REVIEWER COMMENTS

Efficiency Stagnation in Global Steel Production Urges Joint Supply- and Demand-side Mitigation Efforts

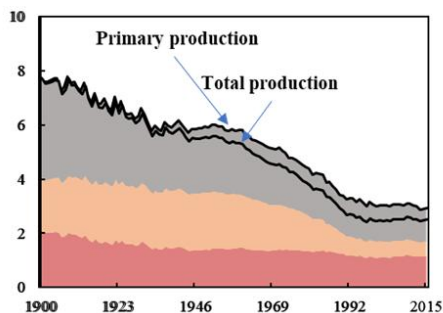
(7) L140, (Fig. 4a-c) --- I think it should be (Fig. 4a, c, e). Moreover, it seems the Fig. 4a and Fig. 4c are the same. Please check it.

We have corrected these mentioned citations of figures. Fig. 4a is the emissions intensity trend of total steel production, which is dominated by the primary production in Fig. 4c. That is the reason why they look similar, but not the same. This is indicated in the figure below.

Notably, the GHG intensity of steel production has been stagnating at ~2.5 t CO_2-eq/t steel after 1995 (Fig. 4a, 4c, and 4e).
